**KWM-2/KWM-2A TRANSCEIVERS
SERVICE BULLETIN NO 8**

EQUIPMENT: KWM-2 Transceiver (522-1611-000)
KWM-2A Transceiver (522-1792-000)

SUBJECT: A. Eliminate AGC overshoot on noise pulses and provide dual time-constant action
B: Change source of delay bias to the AGC rectifier
C. Add delayed-decay (hang) AGC to the rf amplifier

Part A, Schematic Change

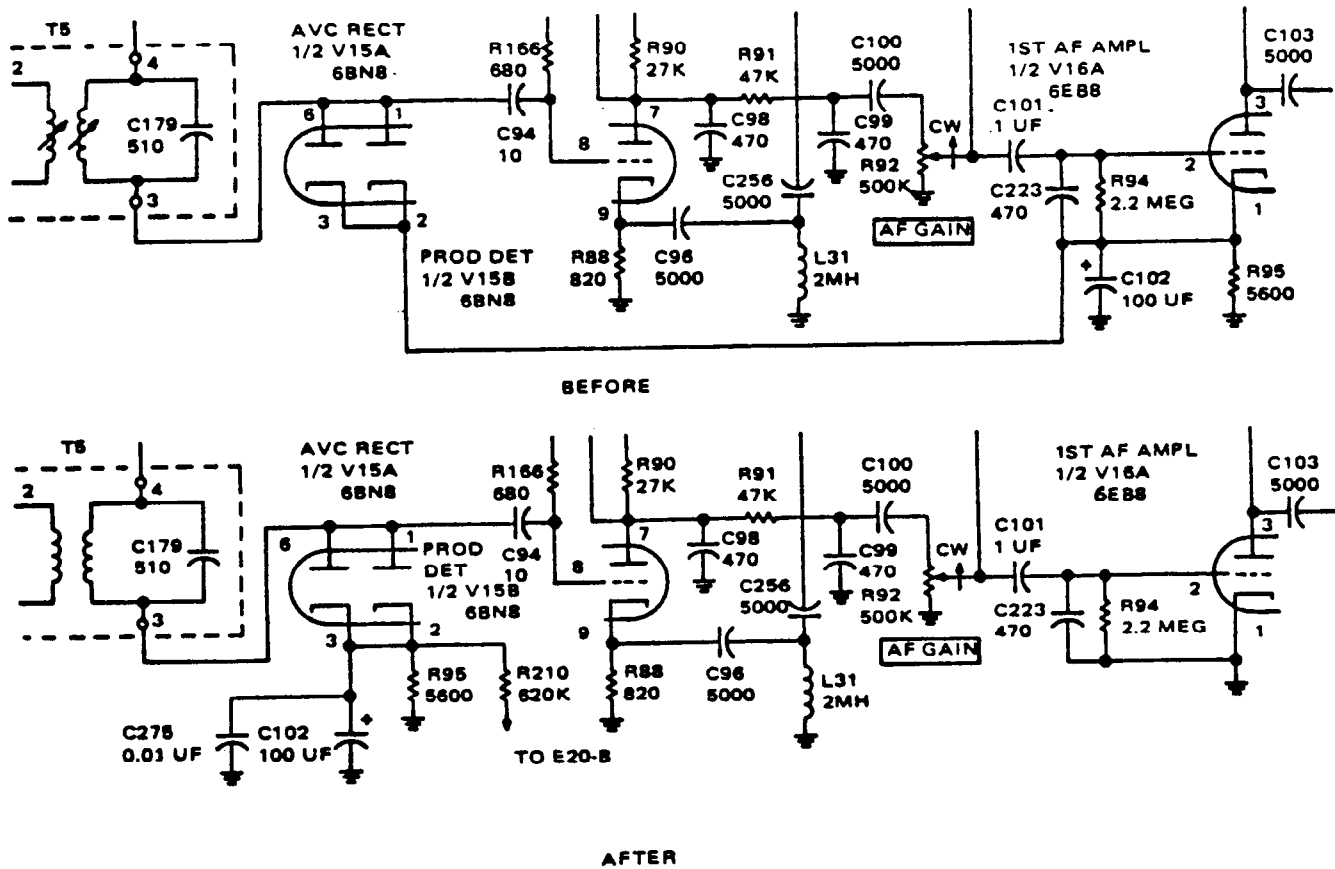
3. Part A: Eliminate AGC overshoot on noise pulses and provide dual time-constant action:

(b) Remove all components attached to E30-C, as follows:

- 1) 4700-ohm 1/4-W resistor, R82, connected from T5 terminal, 4 to E30-C.
- 2) 0.01 μ F disc ceramic capacitor, C92, connected from E30-I to E30-C.
- 3) 3.3-m Ω 1/4-W resistor, R83, connected from E30-C to E30-J.
- 4) 0.05- μ F capacitor, C93, connected from E30-C to E30-J.

- 5) 150-k Ω 1/2-W resistor, R180, connected from TS8-1 to E30-C.

- (c) Remove 0.001- μ F disc ceramic capacitor, C256, connected from TS8-1 to ground ring on power connector.
- (d) Connect R83, 1.5-M Ω 1/2-W resistor (745-1485-00), from E30-C to E30-J.
- (e) Connect C93, 0.47- μ F capacitor (913-3804-00) from E30-C to E30-J.

- (f) Connect R82, 4700-ohm 1/2-W resistor (745-1380-00), from T5 terminal 4 to TS8-1. Use sleeving on leads and route this resistor around E30.
- (g) Connect R180, 680-k Ω 1/2-W resistor (745-1471-00), from TS8-1 to E30-C.
- (h) Connect C265, 0.01- μ F disc ceramic capacitor (913-3013-00), from TS8-1 to E30-C.
- (i) Connect C90, 0.01- μ F disc ceramic capacitor (913-3013-00), from TS8-1 to ground ring on power connector.
- (j) If no additional modifications are to be implemented, replace all hardware by reversing step (a).
- (k) Mark SB 8A on information chart (280-3778-010) and apply chart to convenient location on unit, or mark existing chart if one is present.

Part B Schematic Change

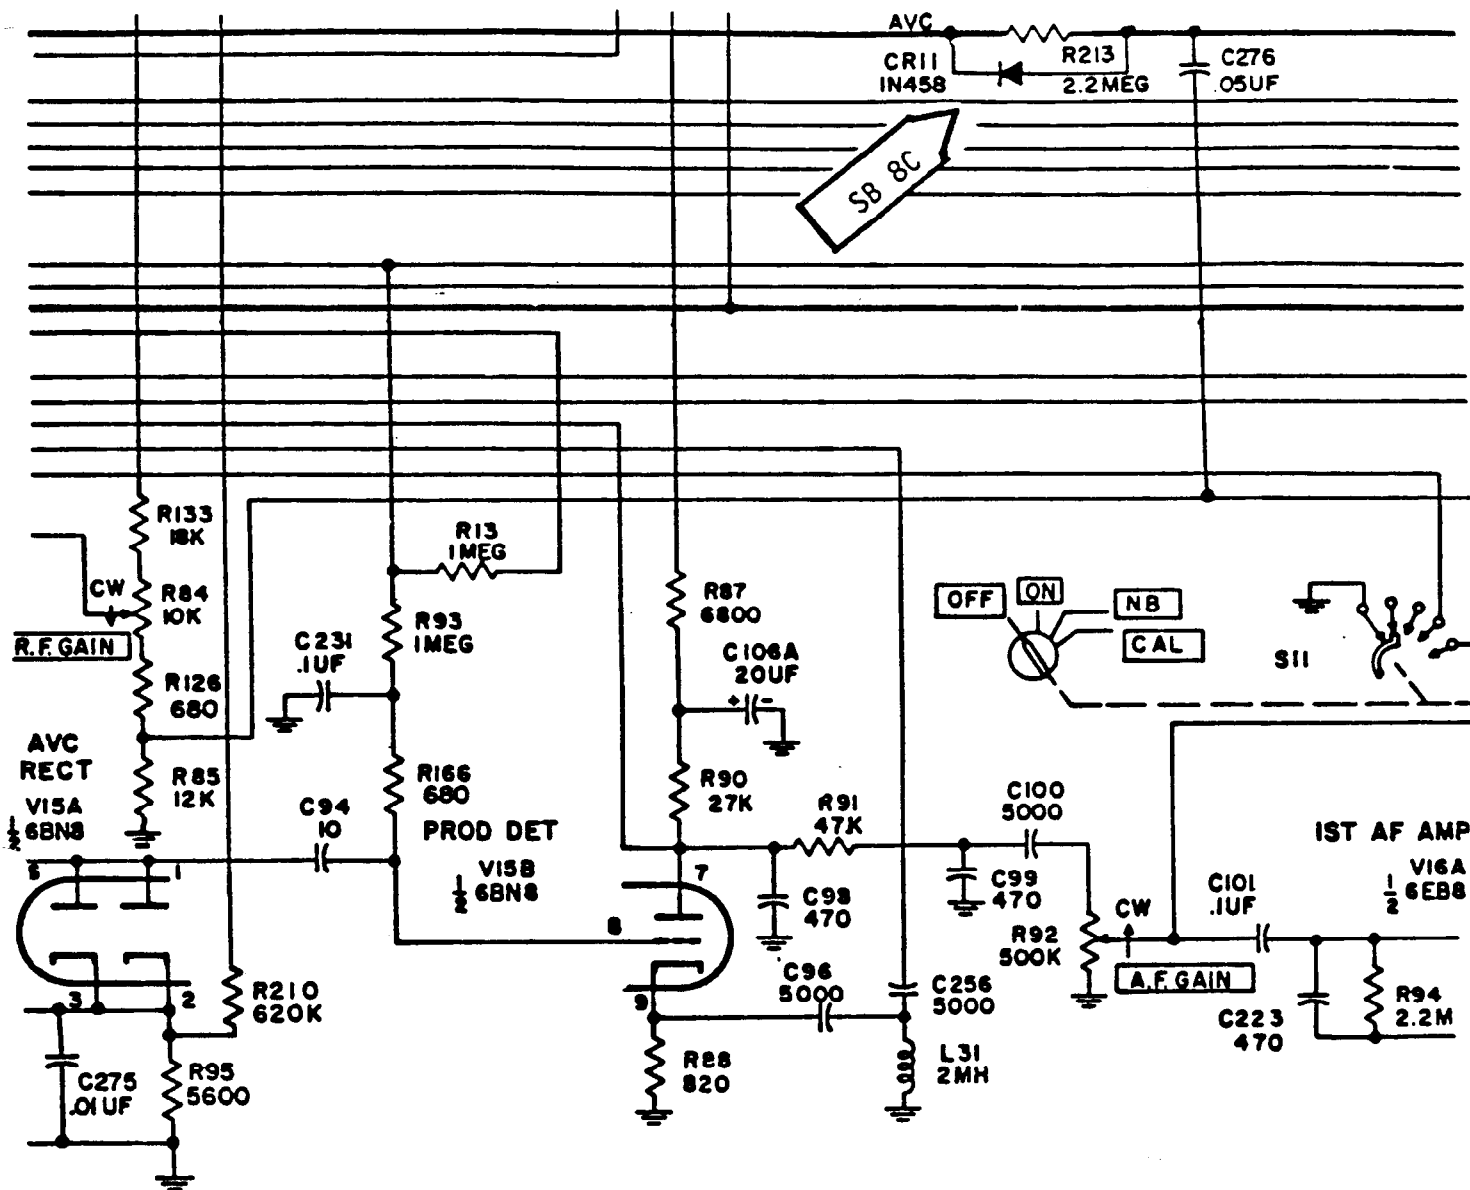
4. Part B: Change source of delay bias to the AGC rectifier:

- Disconnect bus wire at tube socket XV15-2. Remove sleeving and route wire to center shield on XV16. Shorten wire as necessary, connect and solder.
- Add 620 k Ω resistor R210 (745-1469-000) from E20-B to XV15-2.
- Add 0.01 μ F capacitor C275 (913-3013-000) from XV15-3 to nearest ground.
- Mark information chart (280-3778-010) SB 8B. Apply chart to convenient location on unit if one is not present.
